COMMENTS RELATING TO PLANS FOR ENLARGEMENT GROUND FLOOR EXTENSION - 10 EVANGELIST ROAD

PHOTO 1 - INTENDED LOCATION ENLARGED EXTENSION N° 10.

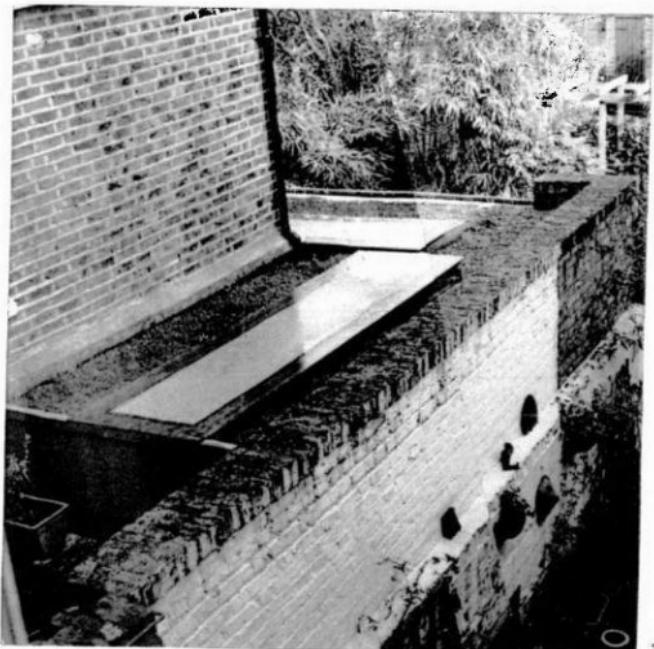
(Note: the photo of the front of the property is of the facades of houses n° 11 and 13 across the road. The other photo is of the existing extension at the rear of the house, but the caption; "current patio area --- with 2-storey wall to the right ---" relates to, and only makes sense for, the extension at house n° 8.)

- 1- EXISTING END-WALL AT HOUSES NO 8, 10, 12, WITH ENLARGED EXTENSION AT NO 12.
- 2- PROPOSED END-WALL DEVELOPMENT AT HOUSES NO 8 AND 10 - (VIEW FROM GARDEN).

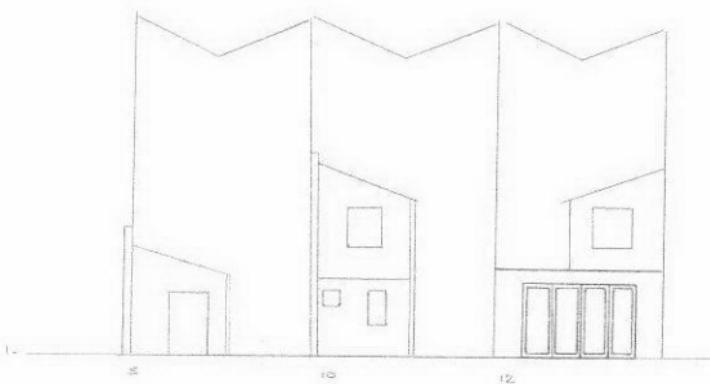
The existing end-wall is shown as built-out in the direction of the garden, although it is unclear by how much. (According to most of the drawings this measurement is around 1½m, but if it is to be the same as the width enlargement, it would be nearer 2½m). The roof consists of 3 squares of glass. The end-wall itself is shown as consisting entirely of the 5, aluminium-framed, glass panels of a folding door. This arrangement is very similar to that of the enlarged extension at no 12 next door, and to what is currently proposed for no 8.

If scattered among clusters of traditional houses, the tenth of the modern glass doors at the end of an extension may create visual interest, but in this case the same treatment would appear in three houses in a row, with an impressive total of 15 glass doors arrayed across the width of the three properties (see drawing over). My sense is that the result would be highly conspicuous, overbearing - perhaps even creating the impression of a single dwelling, and not at all in keeping with the architecture of the locality. The arrangement would probably be especially visible from houses 15-21 in Burghley Road.

Photo 4 shows the existing conservatory in the lower left corner, with the almost adjacent 'lightwell' in the enlarged extension next door (grey square in the smaller picture to the right).

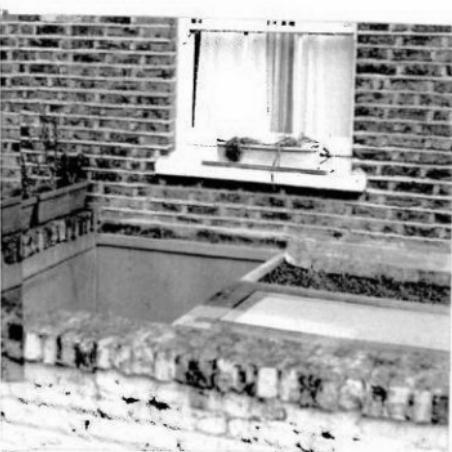
- In its proportion and location the 'patio' space very much resembles the 'lightwell' of the enlarged extension at n° 12, which has not, in my view, been a design success, and is proving to be a source of noise nuisance. Viewed from above, the two spaces would be almost -but not quite, adjacent, and not especially attractive.

Photo 3 shows part of the existing conservatory roof in the space where the patio would be sited.
